ENGINEERING EVIDENCE STATEMENT

SUNBURY SOUTH PSP &
35-60 FOX HOLLOW DRIVE, SUNBURY

PREPARED BY ANDREW MATHESON FOR
ASIA-PACIFIC PROPERTY GROUP PTY LTD
AUGUST 2017

Road Centreline Horizontal Alignment – PSP Exhibited Alignment vs Taylors Revised Alignment

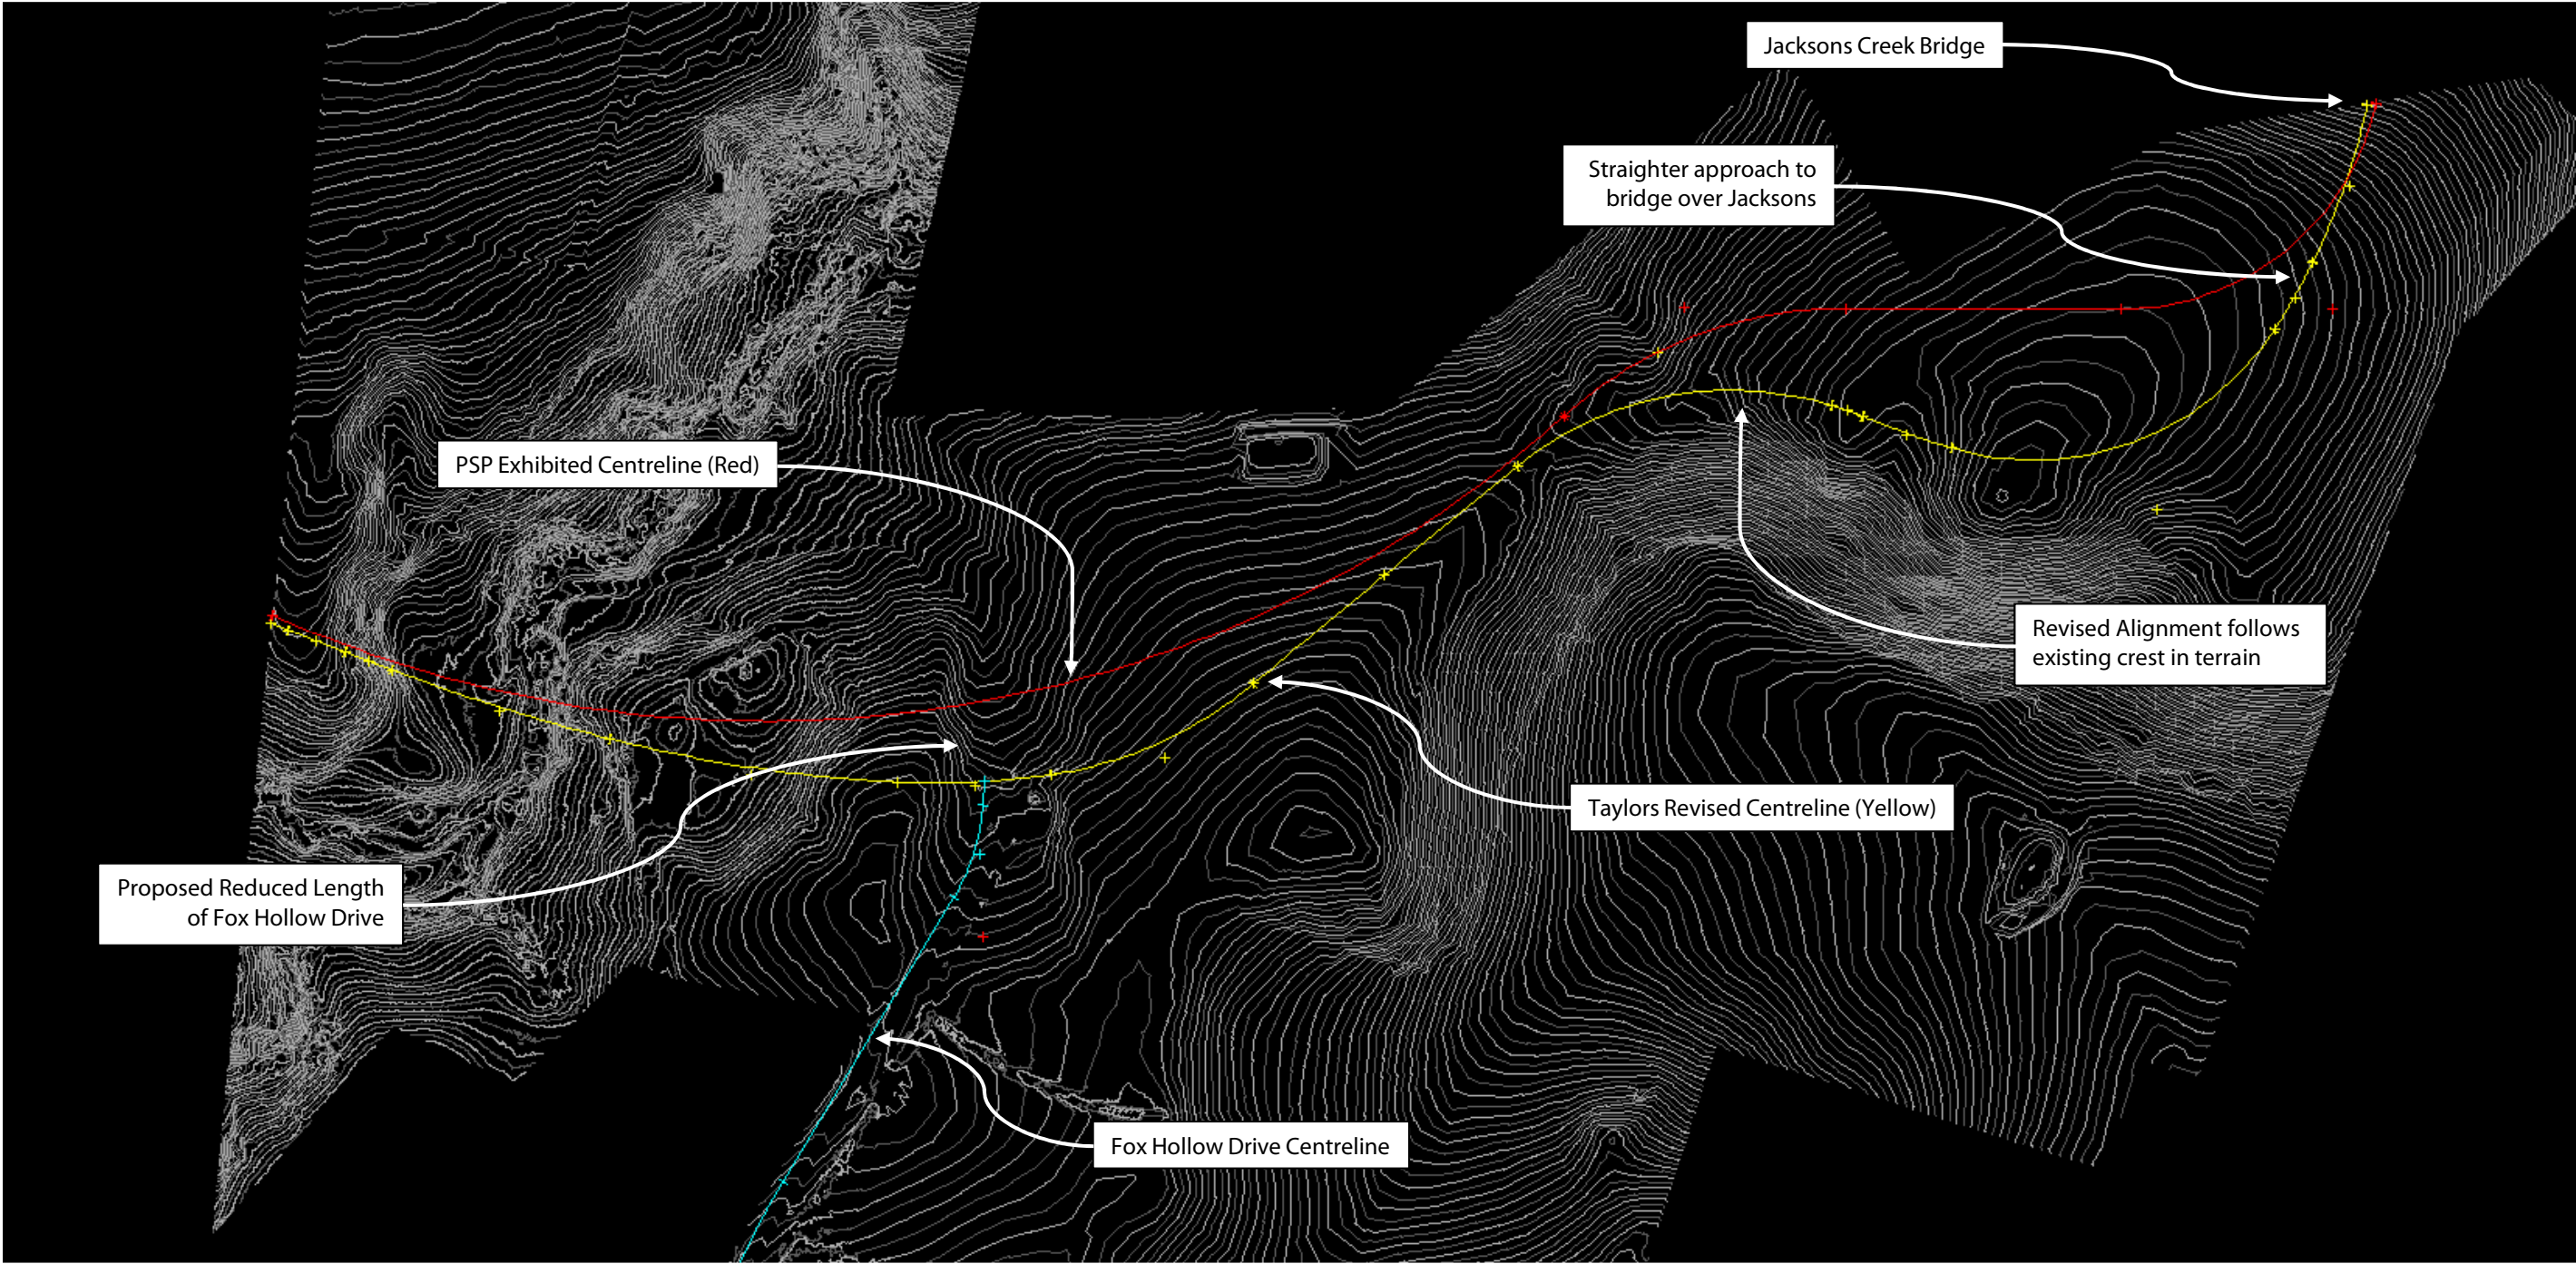
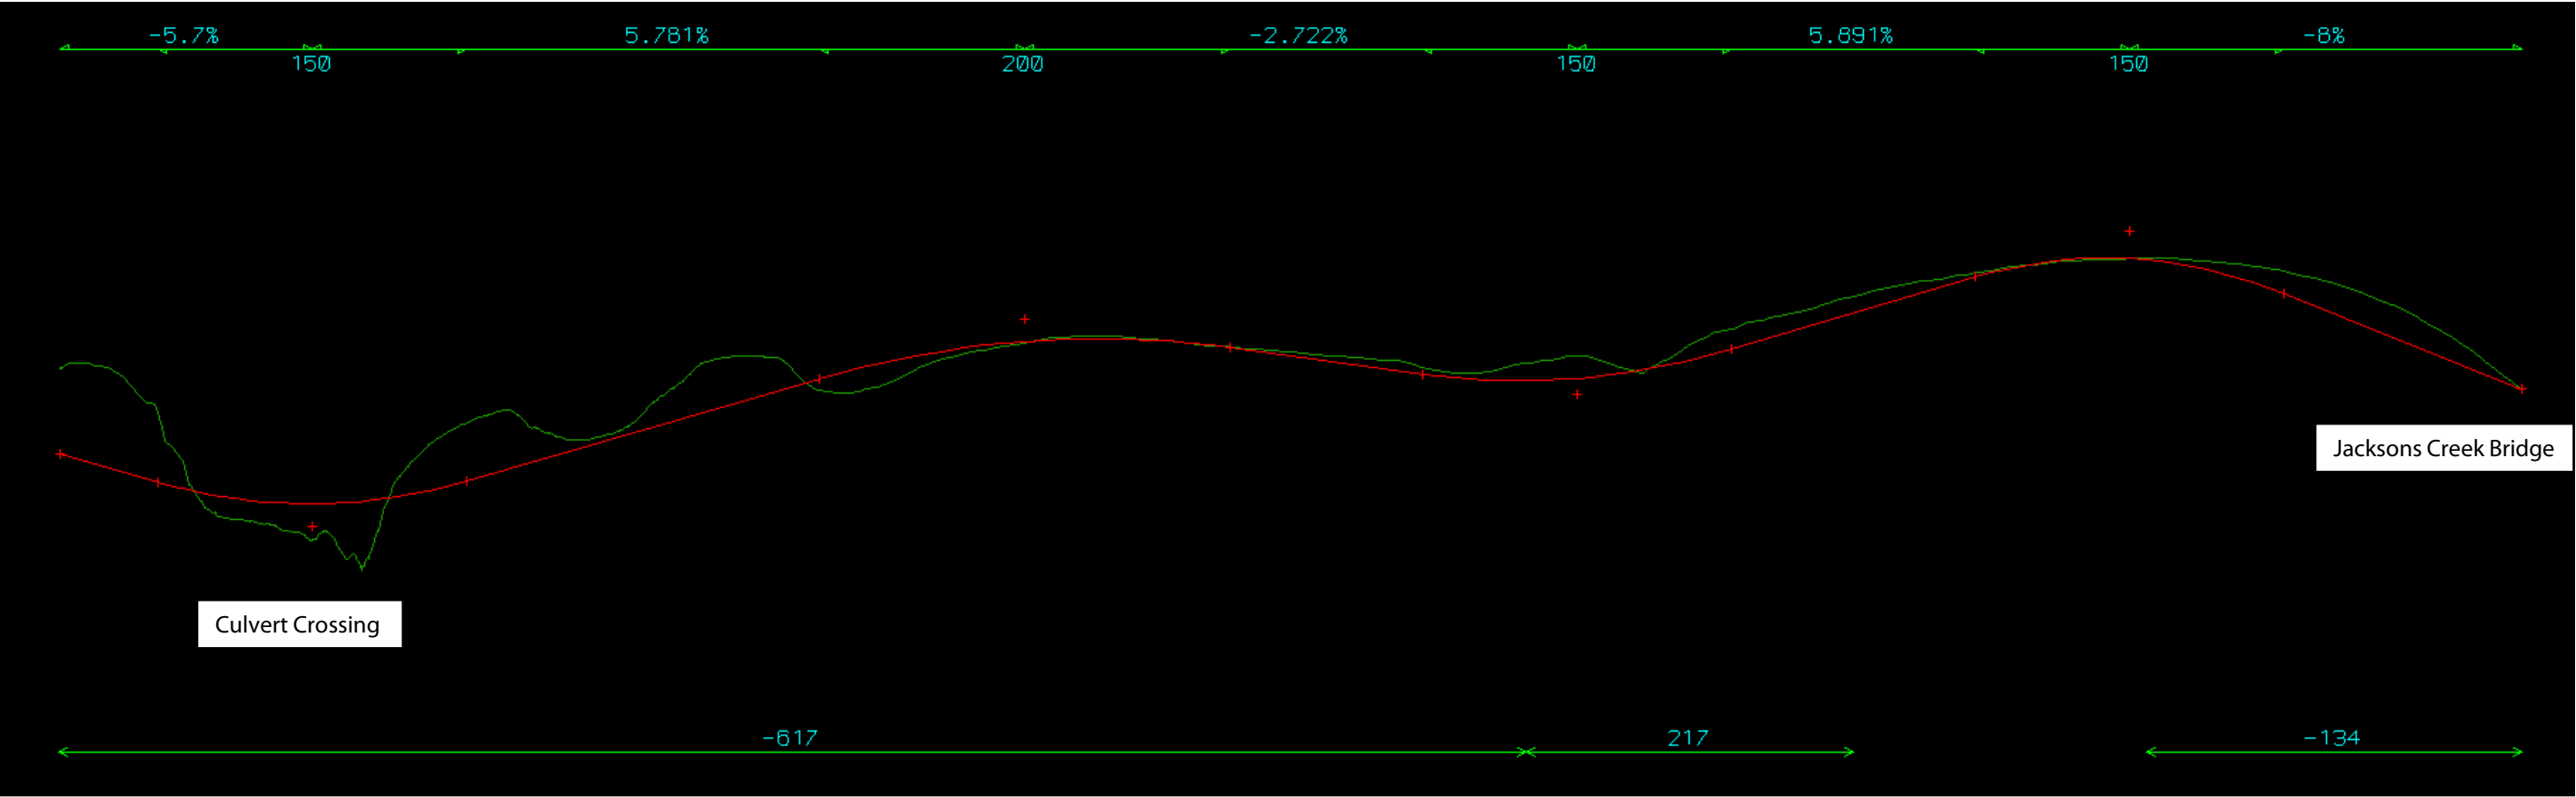
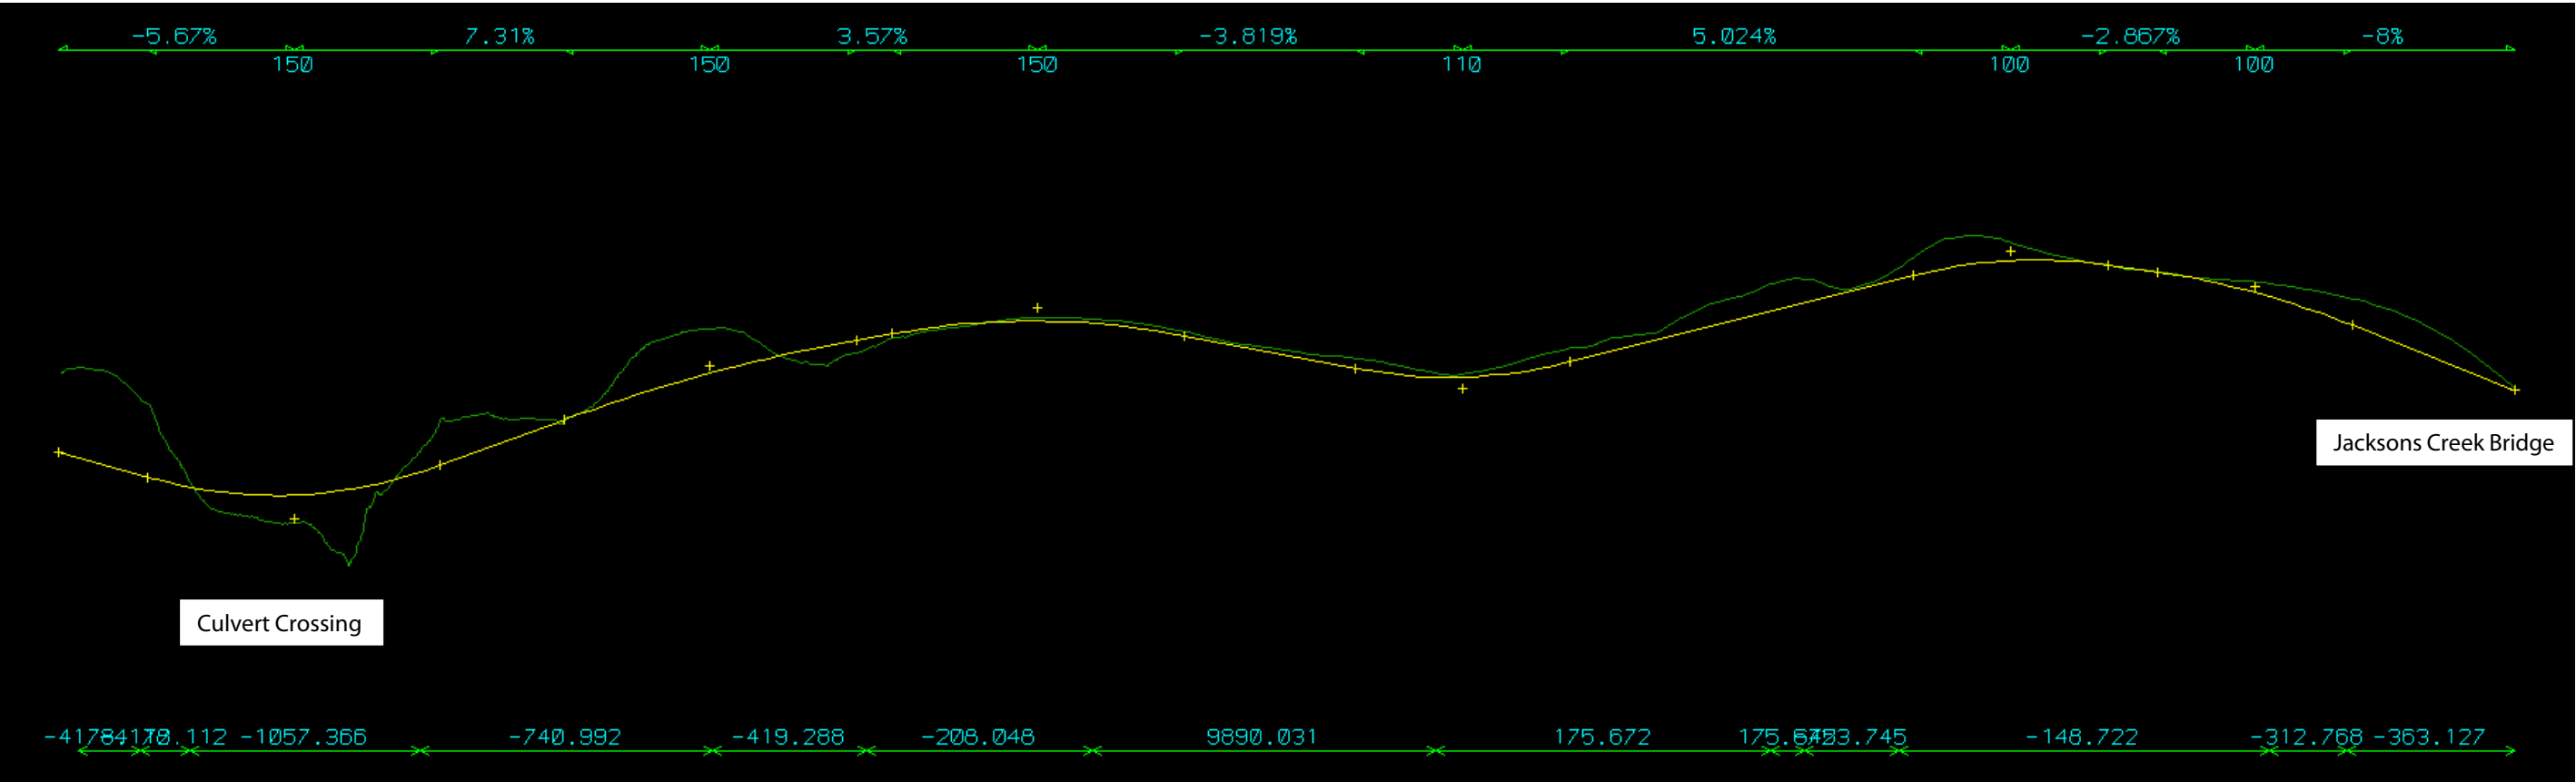
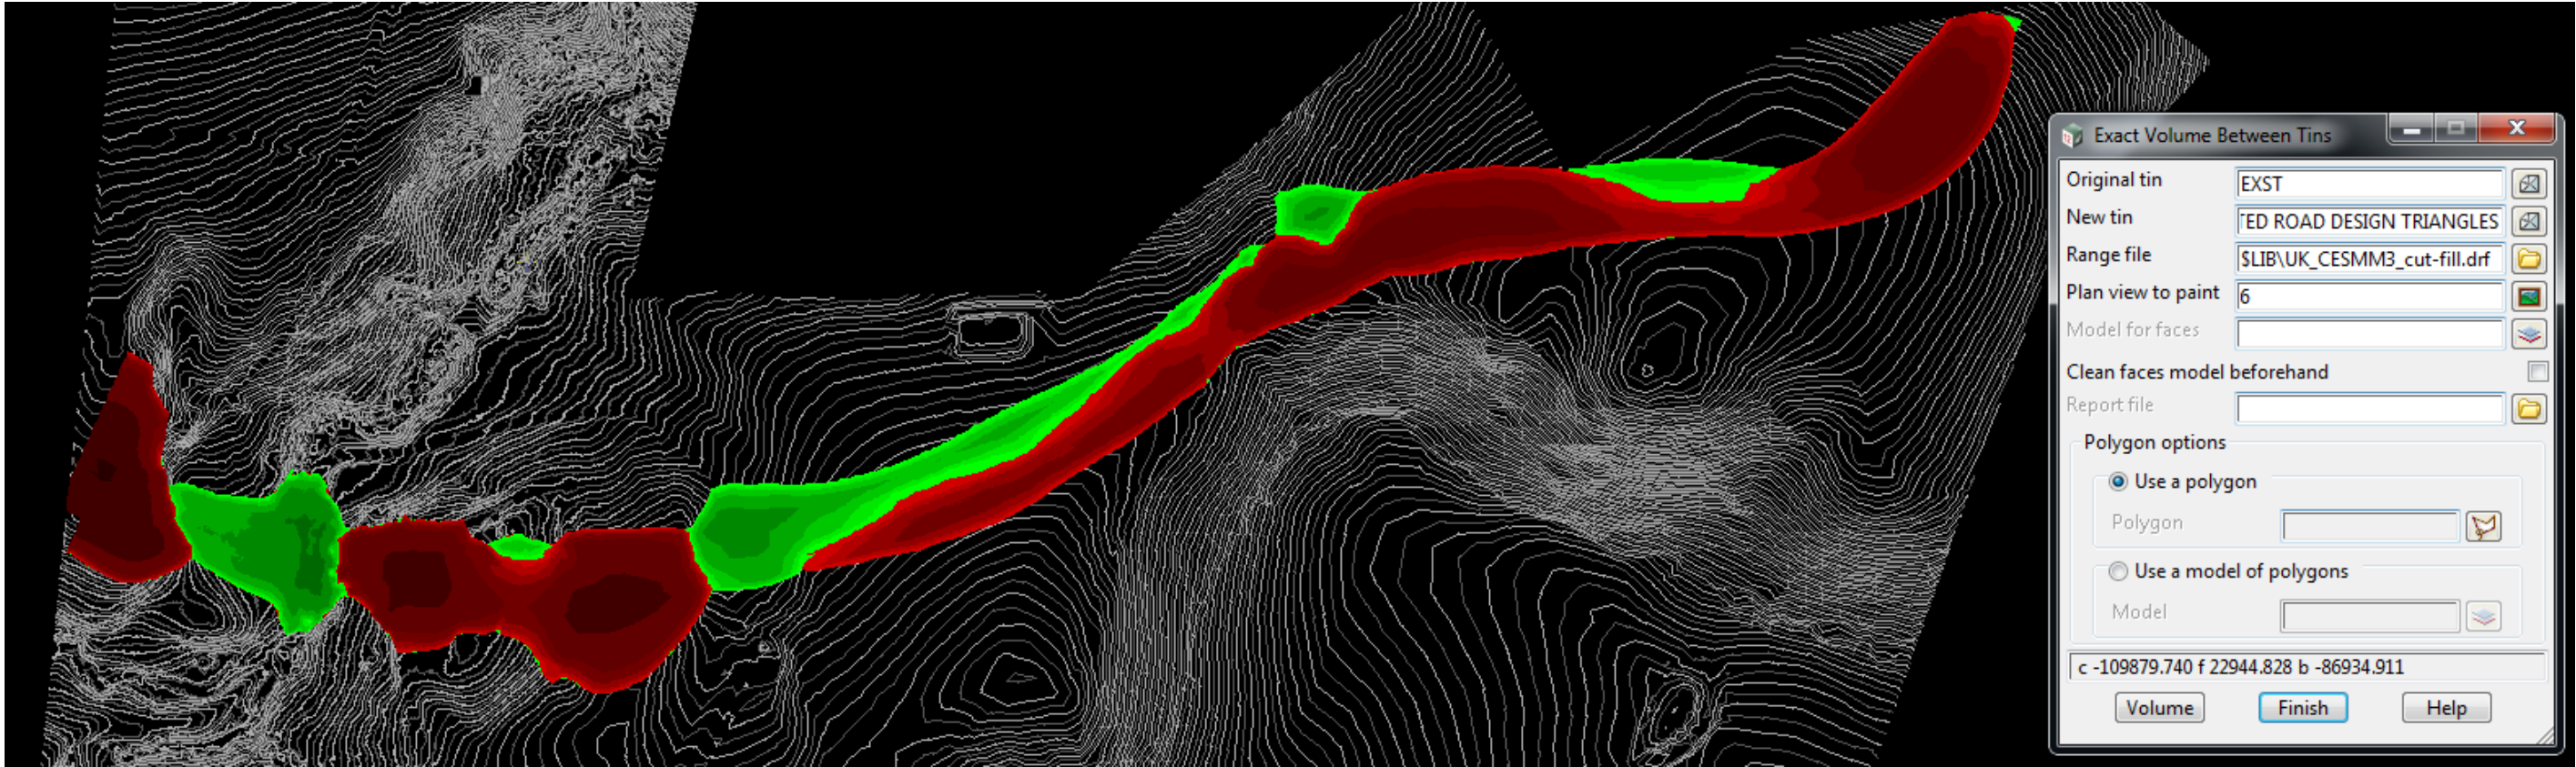
In my opinion, the exhibited PSP alignment for the Connector Boulevard is inefficient. The exhibited alignment pass through land with a significant cross slope. The natural cross-fall along the exhibited alignment averages 1v : 10h or a grade of 10%. Across a 34-metre-wide road reserve, this amounts to 3.4 metres of elevation difference from one side to the other. This difference in elevation must be resolved by either extensive battering or retaining walls. By altering sections of the exhibited alignment to avoid these steeper cross falls, the earthworks component of the Connector Boulevard can be reduced, thus reducing construction and ICP costs. By utilising the existing crest adjacent to the conservation reserve, the slope across the road reserve is greatly reduced. To test these assumptions, I have prepared two designs, the first following the exhibited PSP alignment, and an alternative design utilising the natural terrain as describe above.

- Exhibited PSP Road Length = 1,200 lineal metres;
- Taylors Road Length = 1,260 lineal metres;
- The Taylors Road design having additional 60 lineal metres of length results in more pavement area however is more efficient in earthworks design reducing total excavation volume by approximately 8,500 cubic metres. The total cost of the Taylors alignment, in isolation, is marginally higher than the exhibited PSP alignment, however the location of Taylors' Fox Hollow Drive & Collector Road intersection is further south than exhibited PSP alignment resulting 41 lineal metres less road length in Fox Hollow Drive;

It is my opinion that the revised alignment for the Connector Boulevard is generally in accordance with the exhibited PSP alignment, and achieves the objectives of providing connectivity between Sunbury Road and Vineyard Road while adhering to Austroads design guidelines for urban roads. The revised alignment also has the added benefit of reducing the ICP costs.

- Revise the alignment of the Sunbury Ring Road Southern Link (Connector Boulevard) and corresponding intersection with Fox Hollow Drive to reduce cost to the ICP and earthworks implications onto developable land.
